KING'S CROSSING VILLAGE

SITE PLAN WITH ADJUSTMENTS

KING'S CROSSING VILLAGE
SITE PLAN WITH ADJUSTMENTS
15660 E 6TH AVE, AURORA, CO 80011
COVER SHEET

A TREE MITIGATION PLAN
SCALE: 1" = 30'

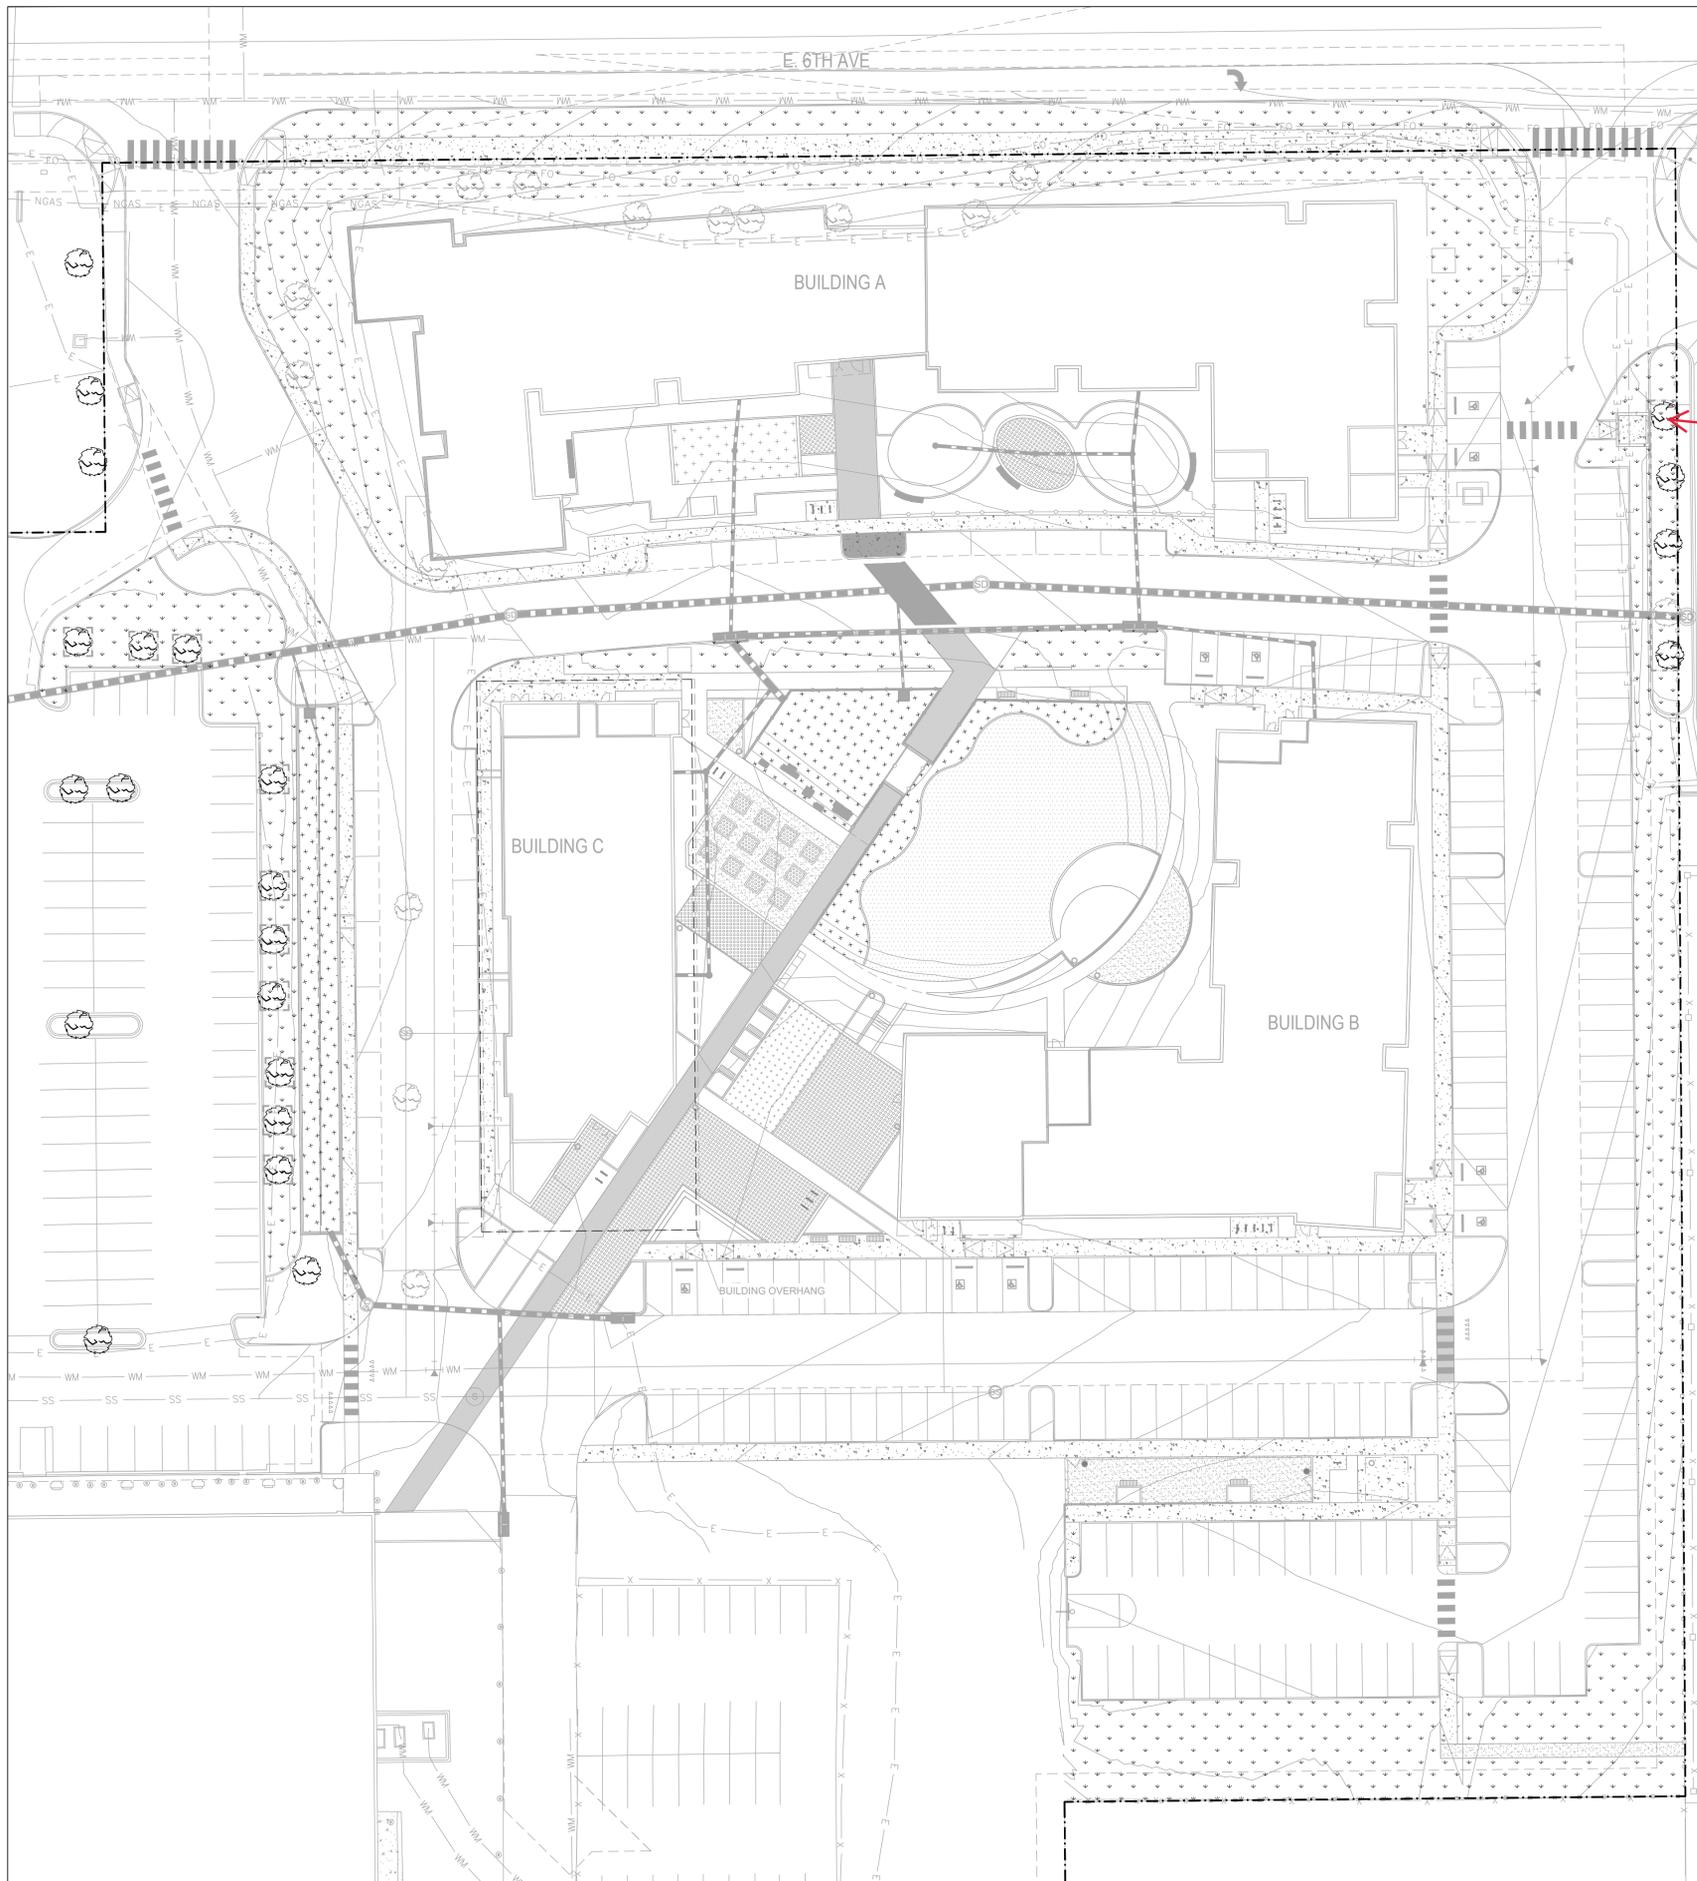
Please identify trees specific to mitigation on the landscape plan. Tree mitigation is always above and beyond the Landscape Code requirements. Any tree that is removed from this site will either require replacement within the landscape or be mitigated through payment to the Community Tree Fund.

Please contact Aurora Forestry, if using a combination of planting back on site and payment into a community tree fund this will require a calculation to determine tree mitigation fee.

The note above is not correct as there are existing trees shown to remain. Please revise note.

1 SDP BUILDING A - NORTH ELEVATION
 1/16" = 1'-0"

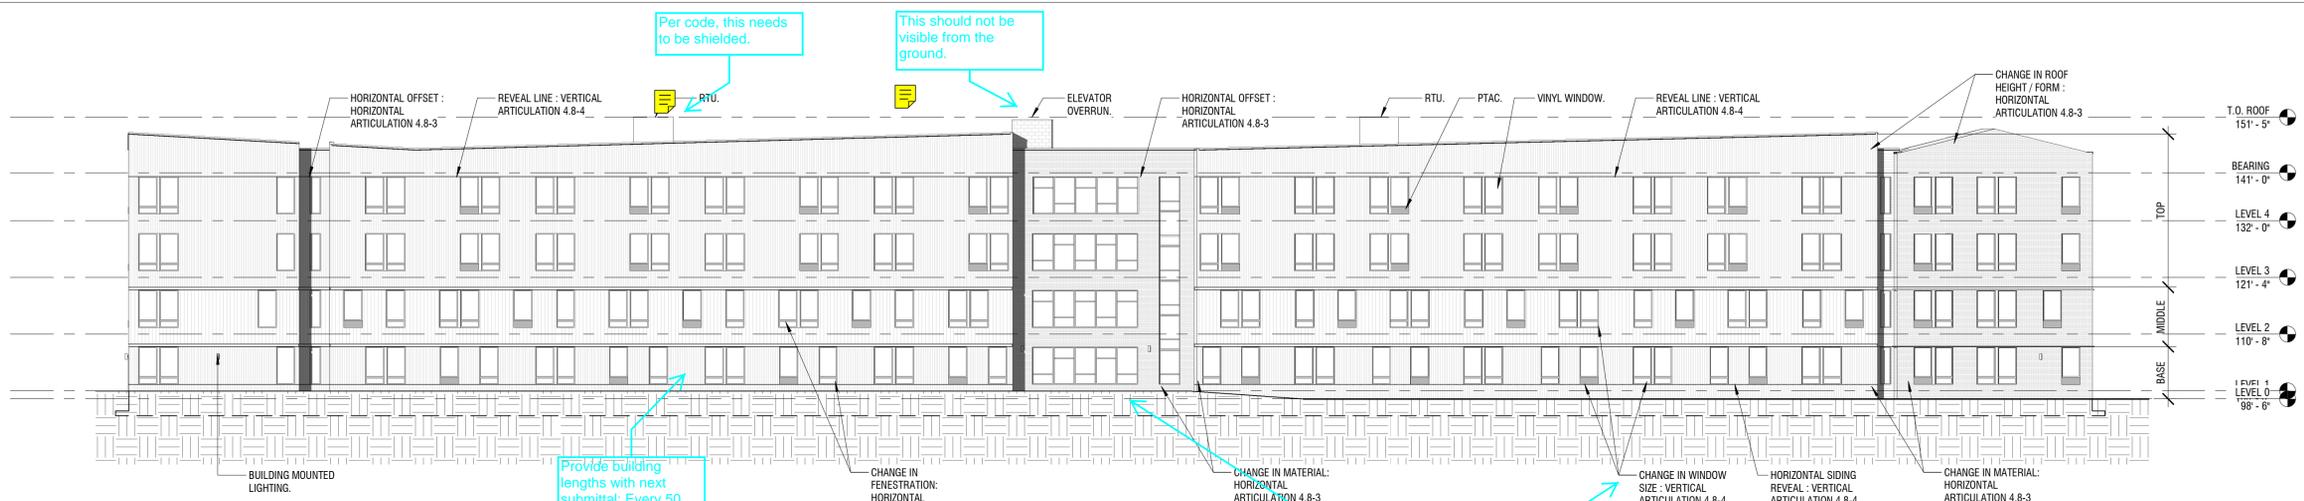
Provide building lengths with next submittal: Every 50 linear feet, mixed-use and multifamily developments shall use at least two of the horizontal articulation methods shown in Table 4.8-3 at an interval of 50 feet or less on each street facing building façade.

2 SDP BUILDING A - NORTH ELEVATION
1/16" = 1'-0"

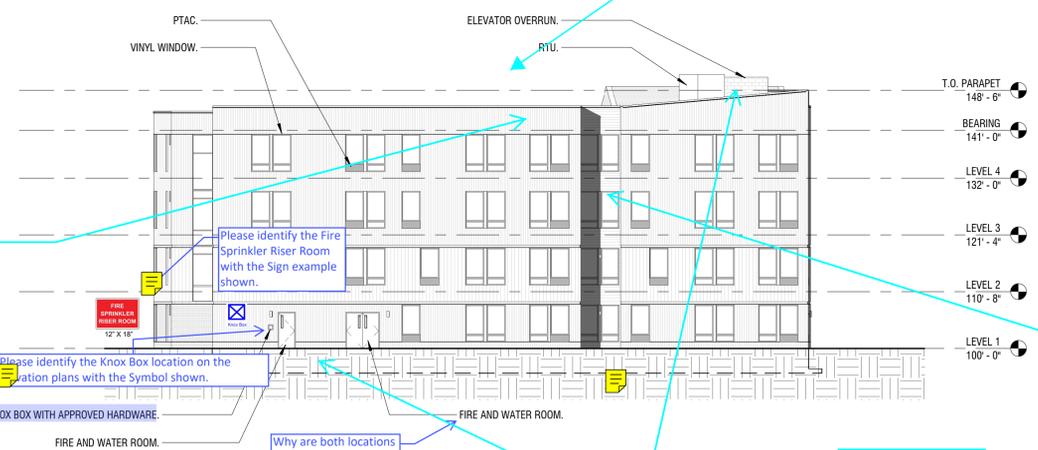
Please add some visual interest to this elevation. Four-sided building standards are provided to eliminate the common treatment of "backs" of buildings. There shall be a hierarchy to building façades, but depending on what each façade orients to there may or may not be a "back" side.

Please refer to section 146-4.8.6 (Table 4.8-6) for masonry standards. Either: 60 percent (or 30 percent for an Affordable Housing Structure) shall be clad in brick or stone; or 80 percent (or 40 percent for an Affordable Housing Structure) shall be clad in stucco; or 80 percent (or 40 percent for an Affordable Housing Structure) shall be clad in a combination of stucco and brick, or stucco and stone.

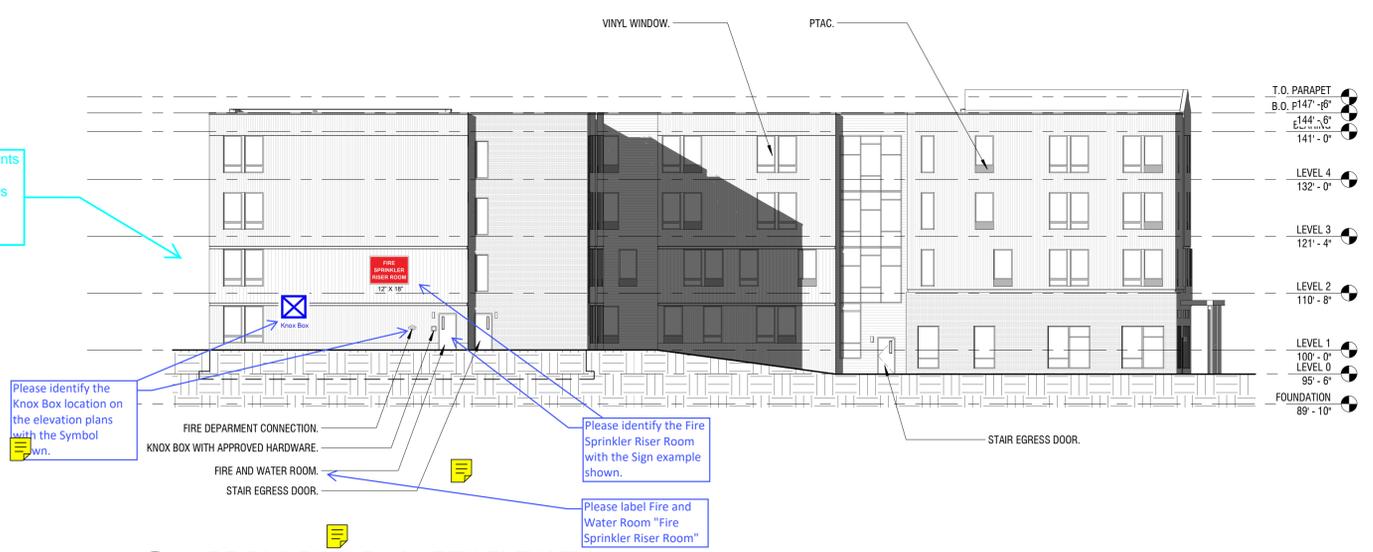
Please see comments on prior sheets regarding elevations and roof lines.

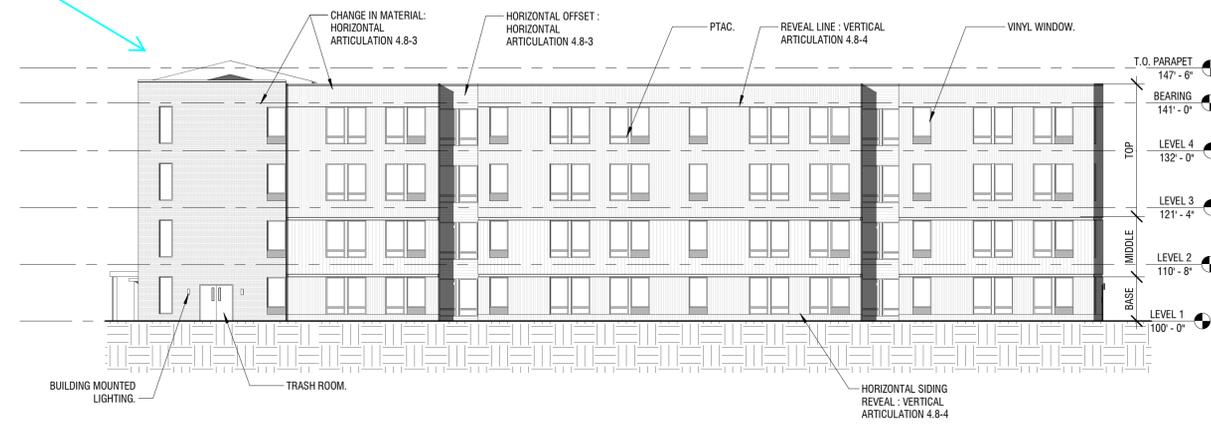
Please see comments on prior sheets regarding elevations and roof lines.

2 SDP BUILDING C - NORTH ELEVATION
1/16" = 1'-0"

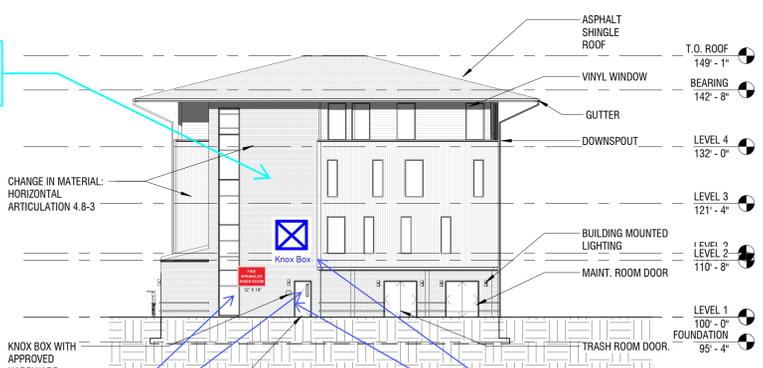
Add more visual interest to this elevation.

Please identify the Fire Sprinkler Riser Room with the Sign example shown.

1 SITE DEVELOPMENT PLAN
PH-01 SCALE: 1/16" = 1' - 0"

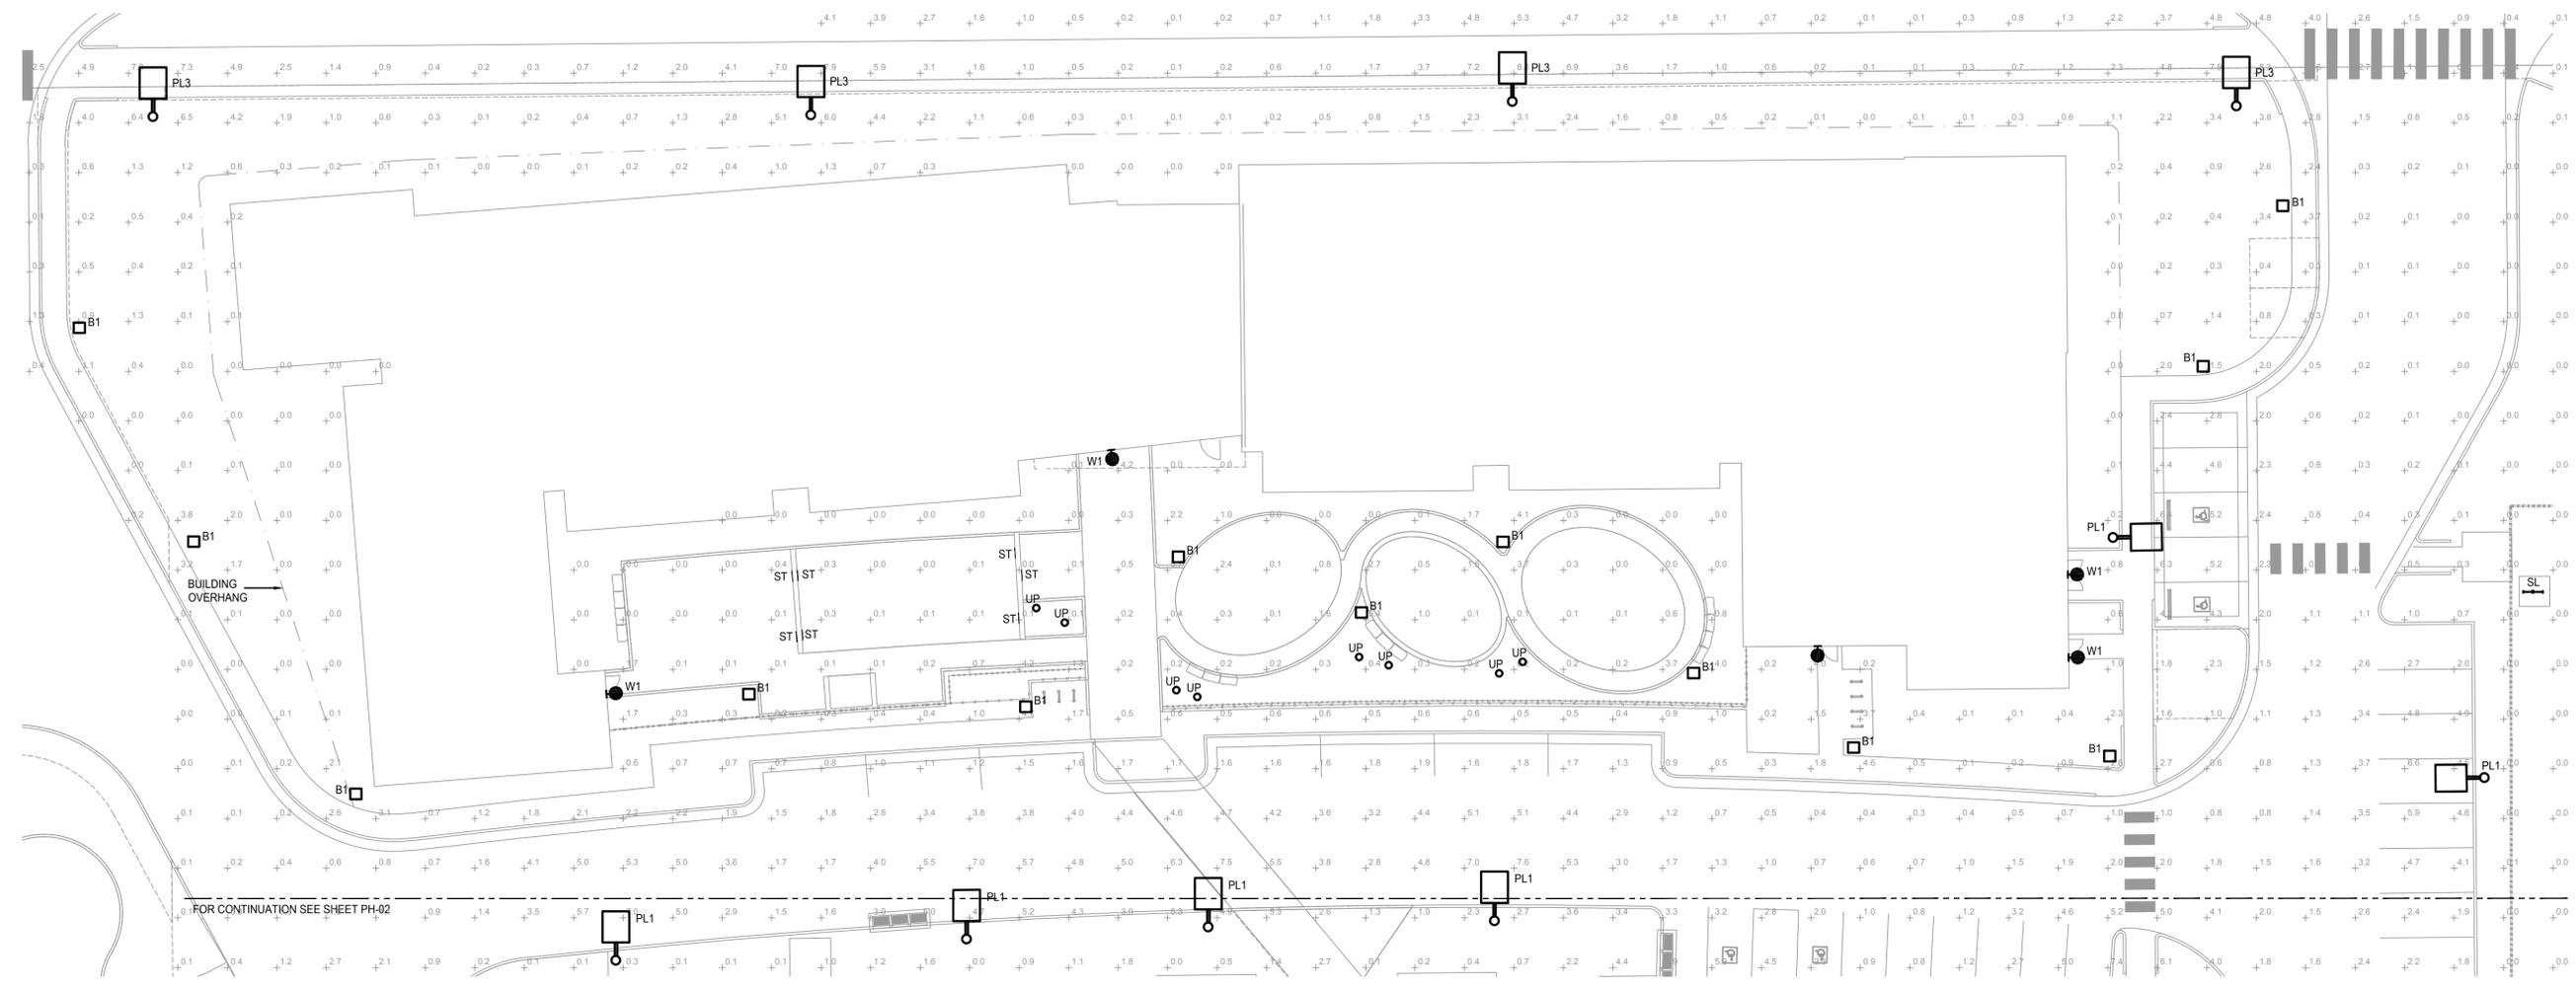
The photometric plan must show and label the location of the internal site accessible route. Provide a minimum of 1 foot-candle of lighting within the accessible route.

ACCESSIBLE ROUTE NOW SHOWN ON PHOTOMETRIC PLANS.
